# PRELIMINARY SITE PLANS

## STARTING GATE SHELL

DESCRIPTION:  
60% PRELIMINARY PLANSET  
PUD SUBMITTAL

UTILITY PLAN

C-401

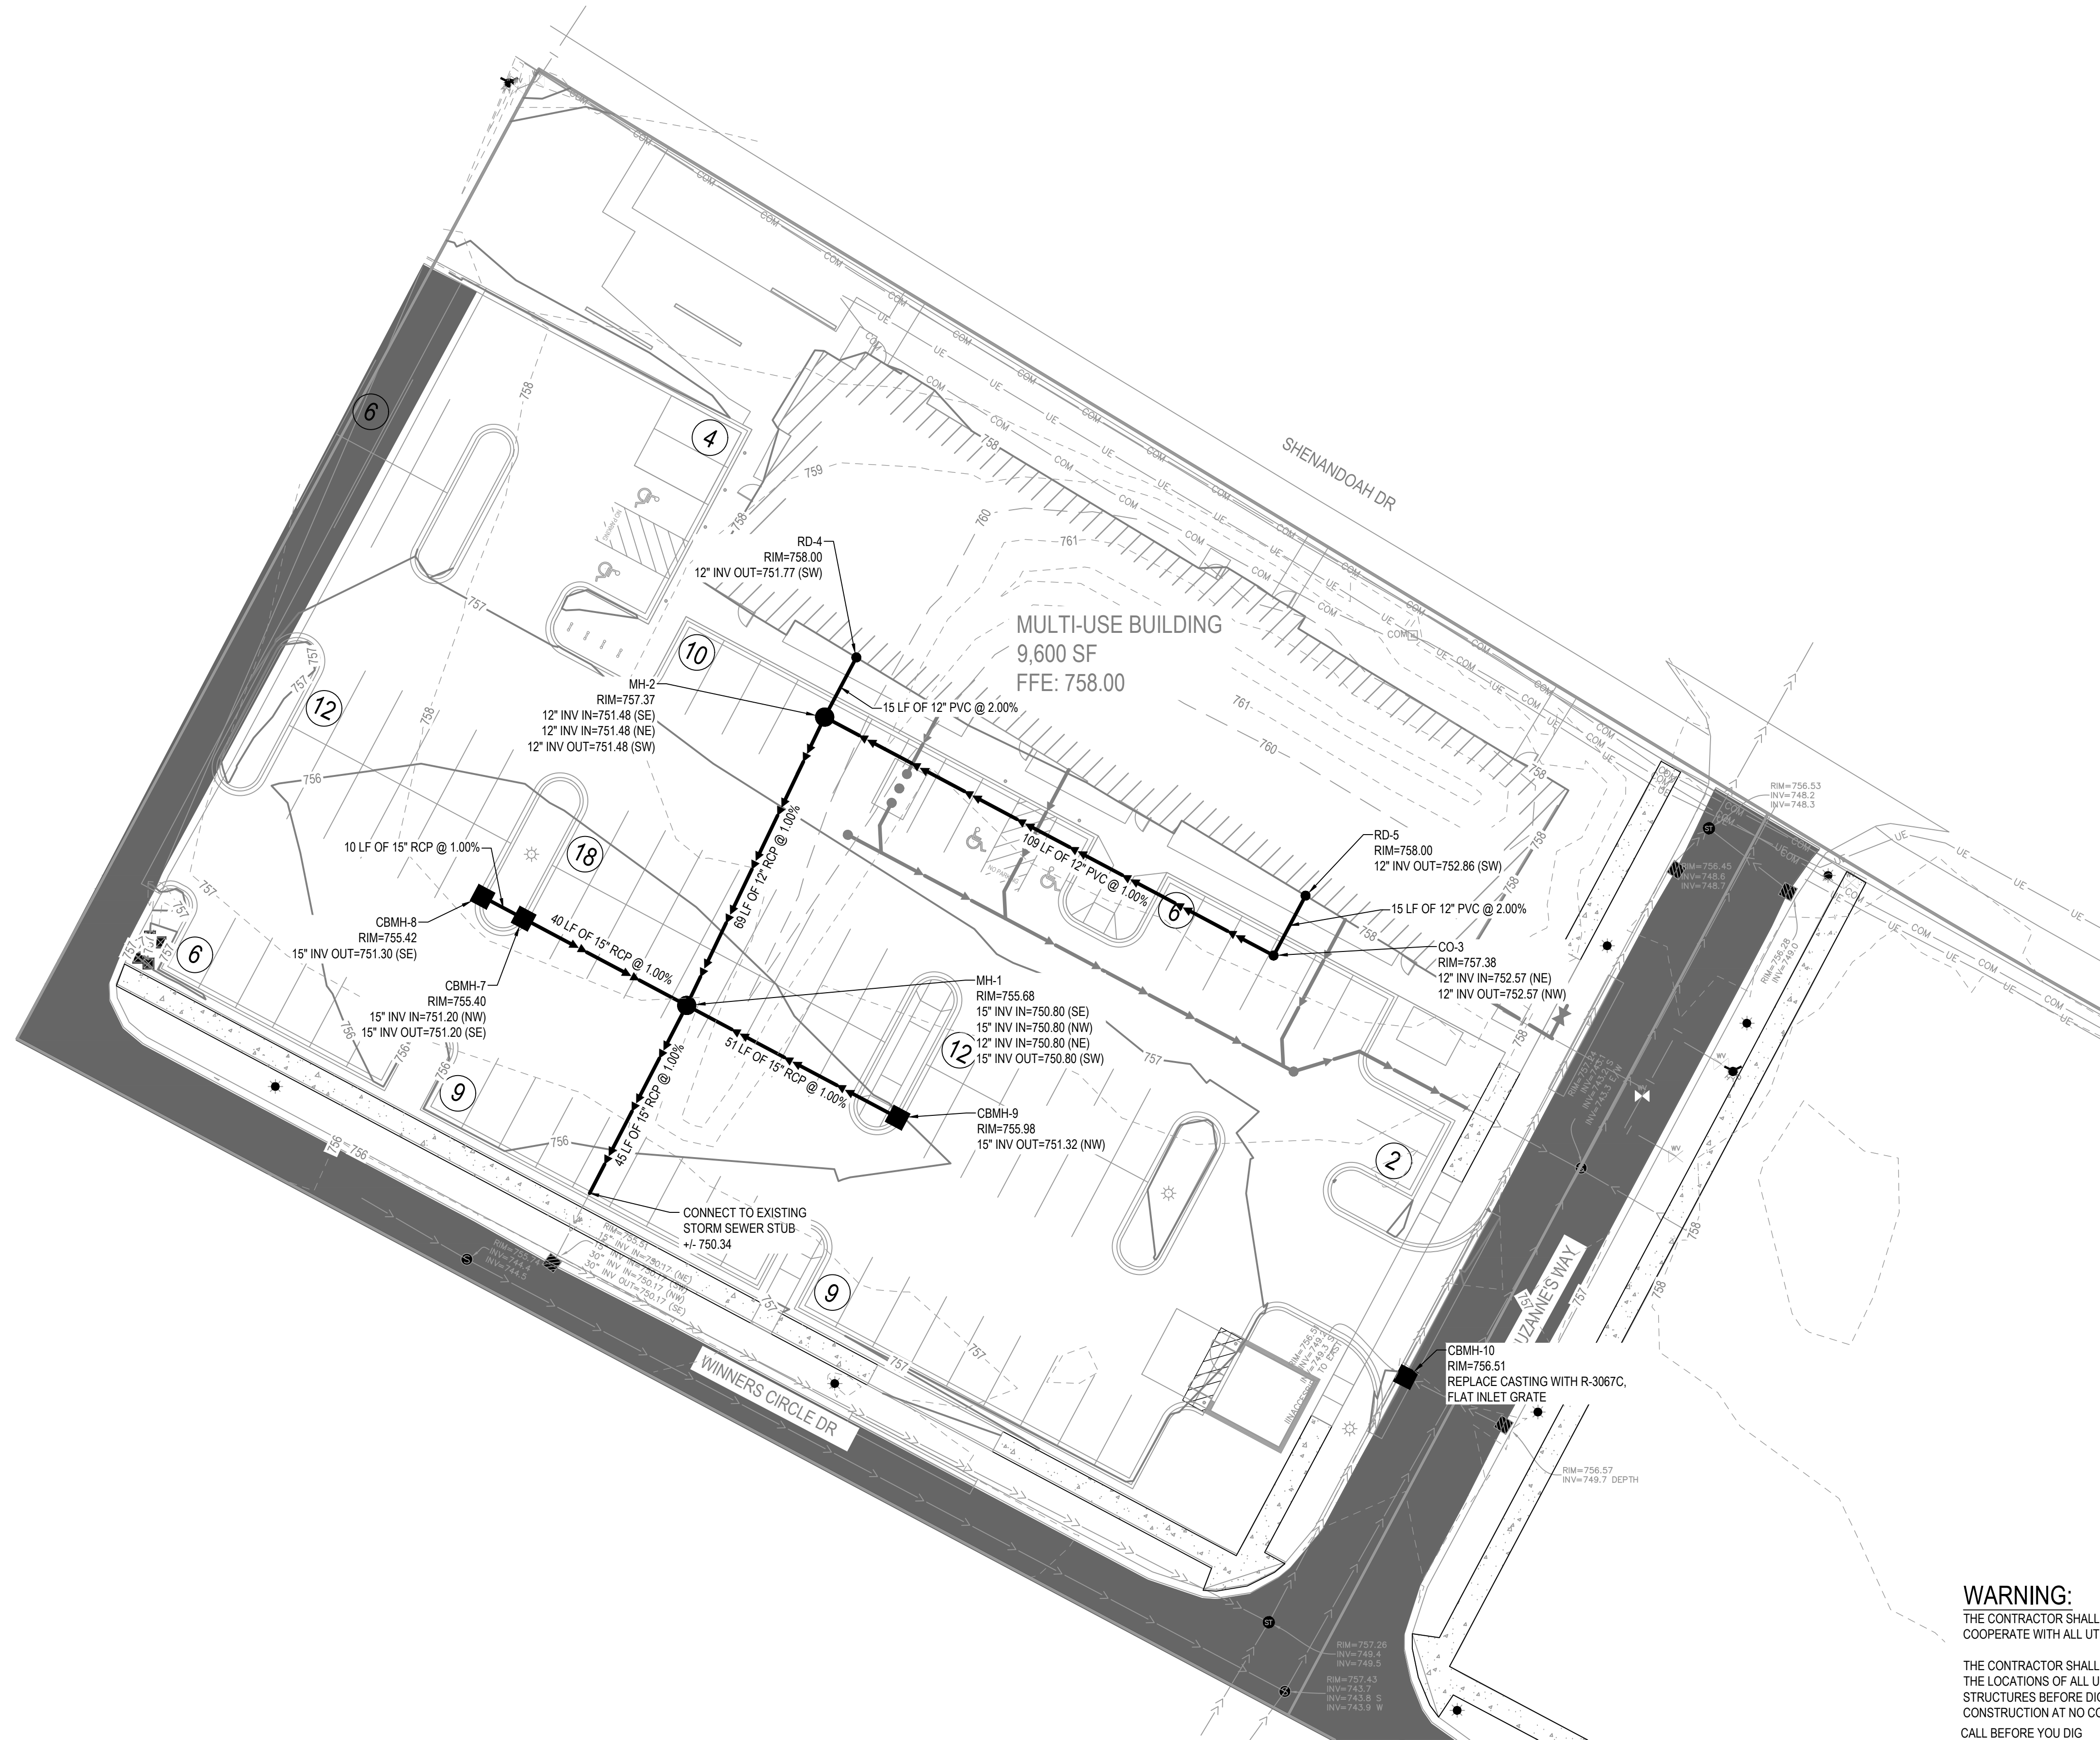
All Sanitary Sewer  
service shall be SDR 26

Correct Rim Elevation

Private hydrant  
refer to SPU spec

Field verify depth and  
location

Connection must  
be made with no  
kinks to the  
alignment.

No horizontal bends  
allowed. Install manhole
